ADDENDUM NO. 04

Northland Corridor Redevelopment Project Phase 4
631 Northland Ave.
Buffalo, NY 14211

Project No. 432607

Project Northland Corridor Redevelopment Phase 4 (BUDC) Addendum No. 4
631 Northland Avenue, Buffalo, NY Contract -
Wendel Project No. 432607 Date 10/31/25

A101B

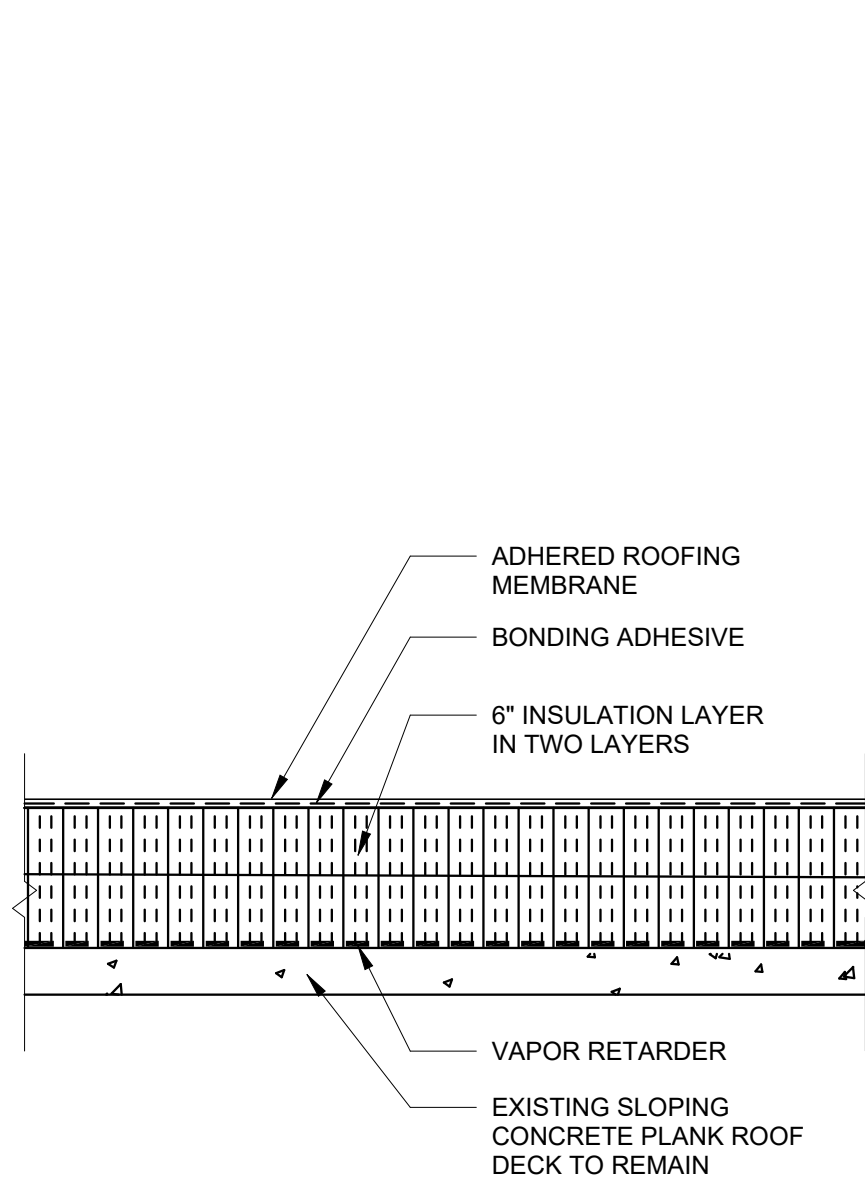
QUESTION: Please provide details for the two railings shown on Drawing A101B and 2/A311 on column line 8.5 from I to J.

ANSWER: Please refer to revised drawing A101B and newly added drawing A454.

REPLACE: Drawing A101B with the revised and Drawing Cover Sheet adding the newly added sheet issued as part of this addendum.

13 ROOF EDGE DETAIL AT CANOPY
SCALE: 1 1/2" = 1'-0"

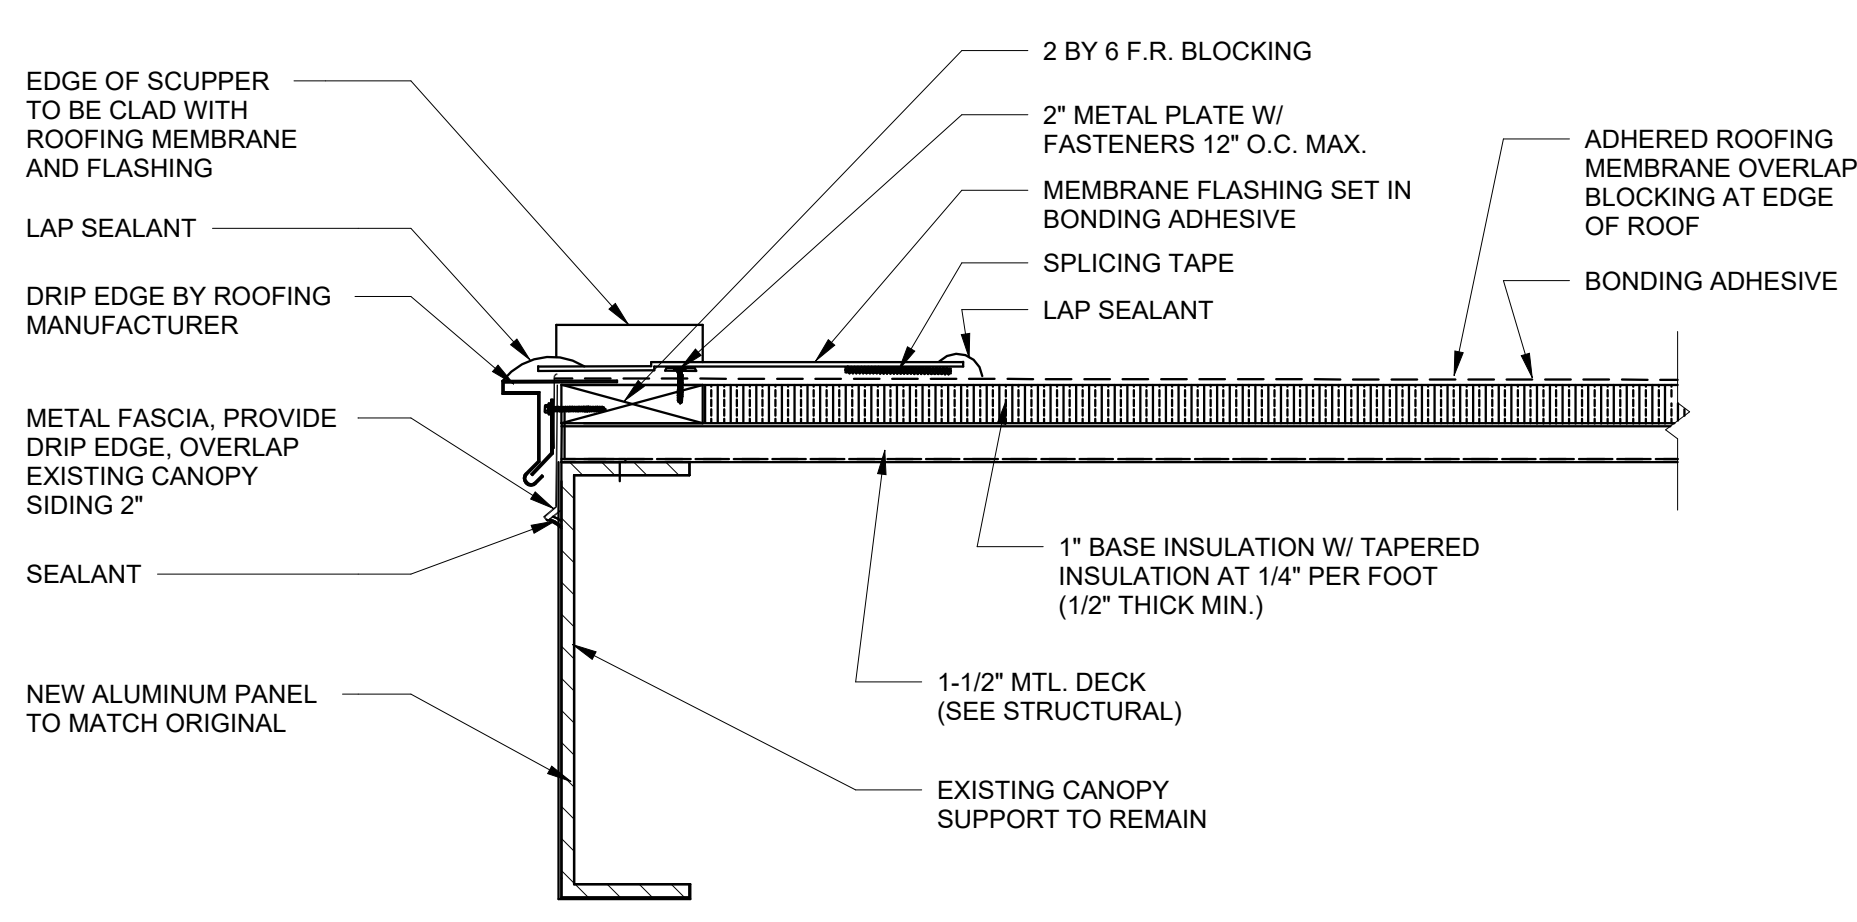
1. Drawing A301, Note C08 calls for metal roofing. Can you please provide a specification for this?
2. There is a section cut through this metal roof, Detail 13/A451 and the detail shows a membrane roof, not a metal roof. Please advise which is correct.

1. Refer to Structural drawings and spec section 053100 Steel Decking.
2. Please refer to the revised drawing sheet A-451 for clarification. The membrane roof is on top of the metal roof and used to pitch the roof.

REPLACE: Drawing A-451 with the revised attached as part of this addendum.

DOOR TYPES
SCALE: 1/4" = 1'-0"

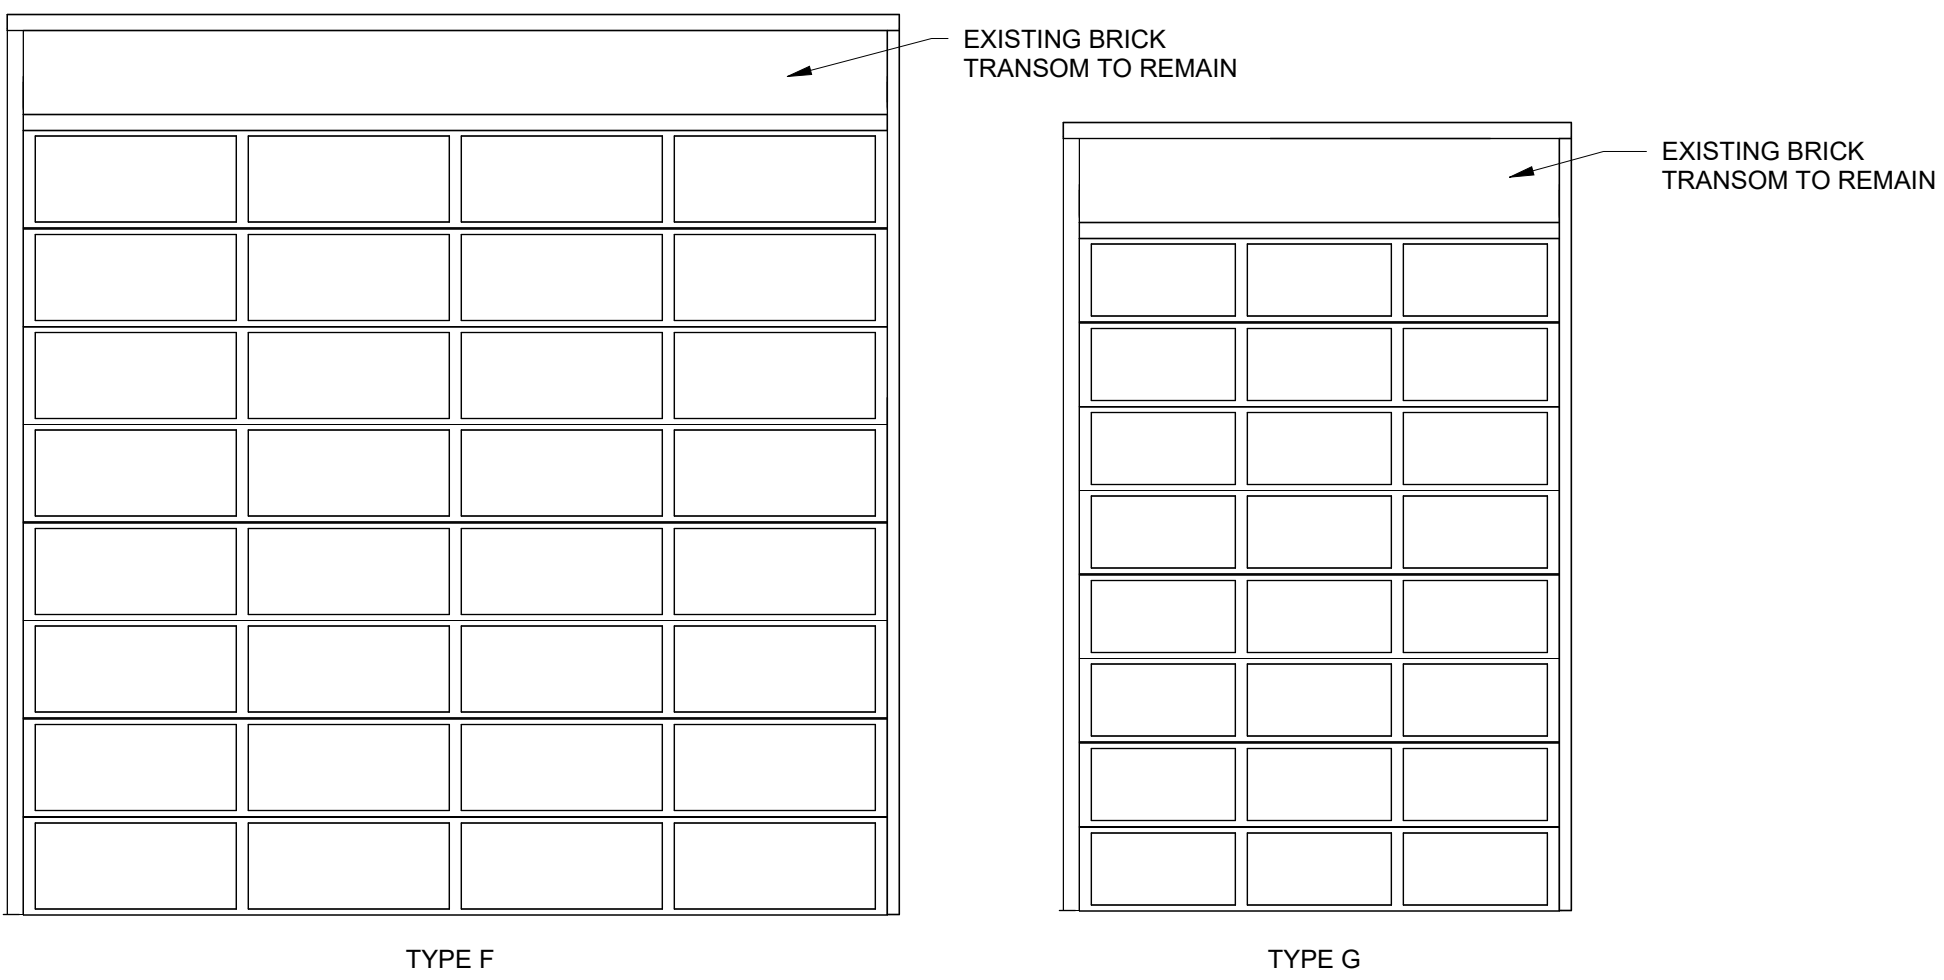
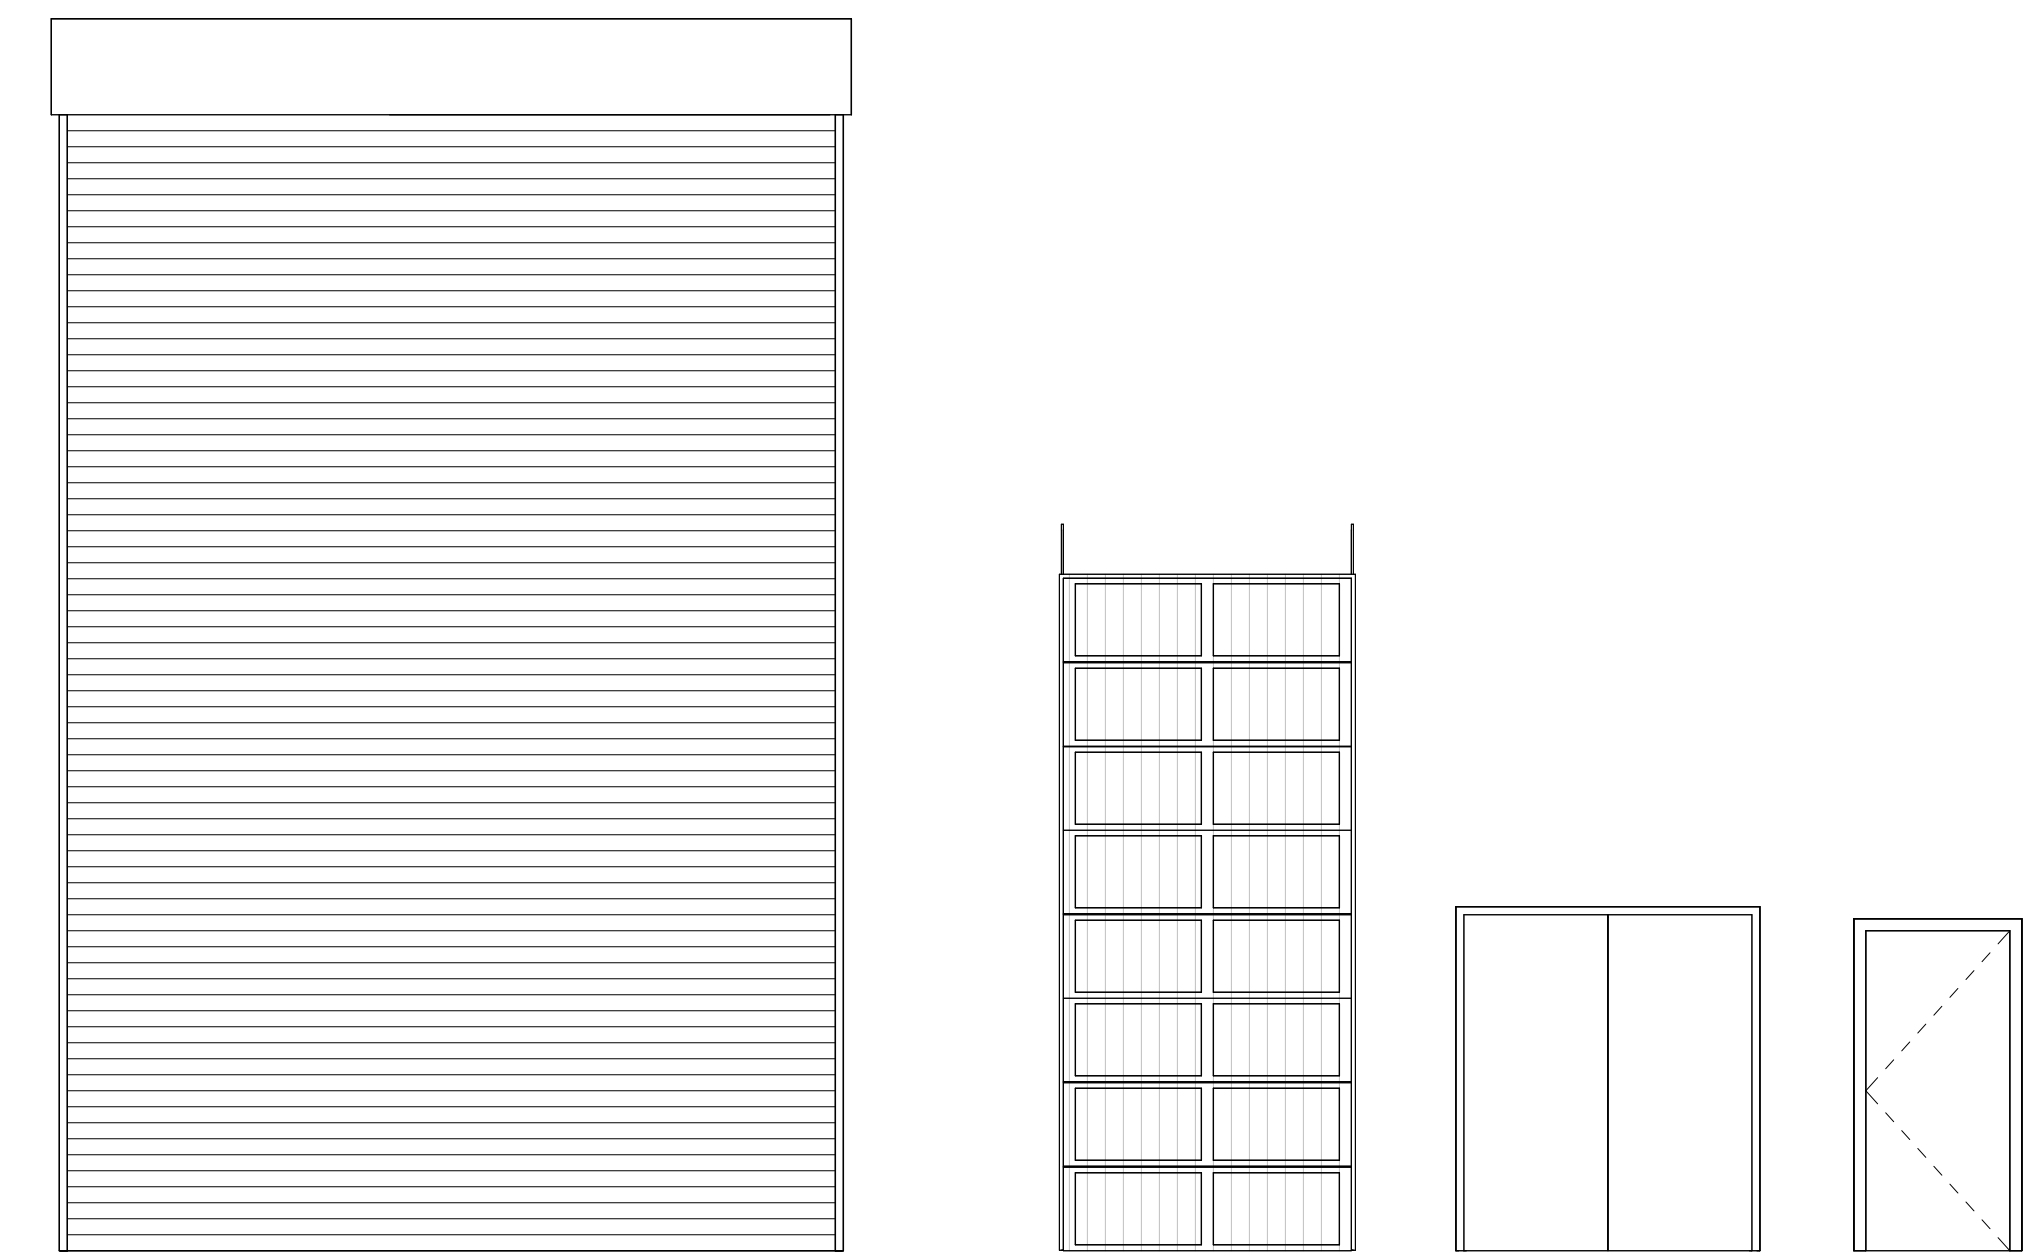
1. Can you please provide hardware sets for each of the openings?
2. Drawing A-900 shows an elevation for Door Type C. Where does this door go? Door Type C is not shown on the Door Schedule. Can you please provide further information for this door?

1. Hardware sets for openings are included in spec section 087100. Please refer to the attached revised section.
2. Please refer to drawing sheet A-900 updated with OH Door Type 'C' location on the west facade and labeled SO4.

REPLACE: Drawing Sheet A-900 revised and included in this addendum.
